APPROVED  
5/15/80 RH  
P 30671  
A REPAIR

SEWAGE DISPOSAL SYSTEM

MARYLAND STATE DEPARTMENT OF HEALTH

Jack Fyock, Jr. IS PERMITTED TO INSTALL ALTER X  
ADDRESS 13775 Triadelphia Road, Glenelg, Maryland PHONE 988-9270  
SUBDIVISION ROAD 6210 Woodleigh Drive LOT  
PROPERTY OWNER Joseph Munday PHONE: 997-8756  
ADDRESS 6210 Woodleigh Drive, Columbia, Md. 21044

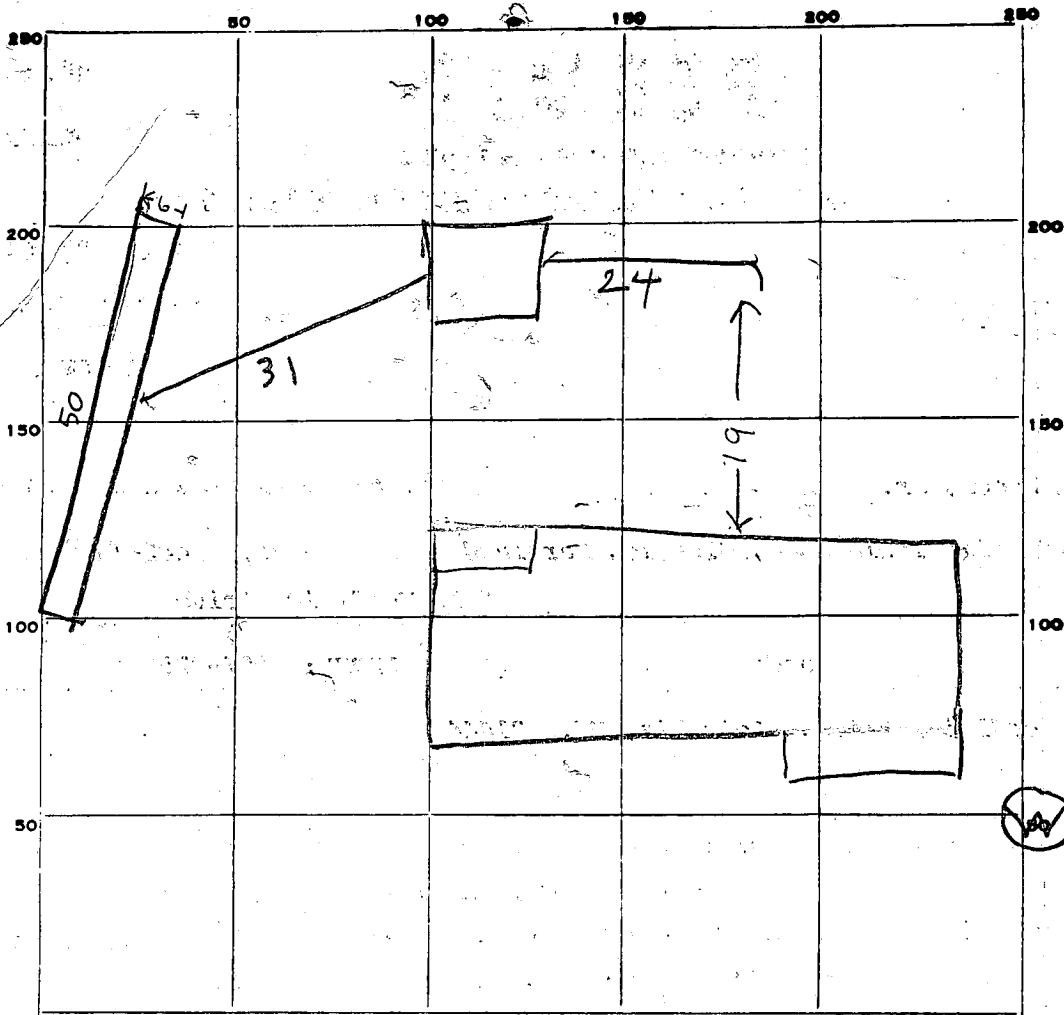
REMARKS 5/15/80 - FF & DM VISITED SITE YESTERDAY &  
DECIDED ON SMALL LEACHING BED UNDERGROUND WATER  
PROBLEM ALTHOUGH ORIGINAL SYSTEM LASTED 20 YEARS  
STONE ADDED AT TIME OF INSPECTION IF LEACHING  
BED FILLS UP IT WILL DRAIN INTO OLD DRAIN FIELD RH

REPAIR. - Trench: 7 1/2 ft deep - 50ft long - 2 ft stone
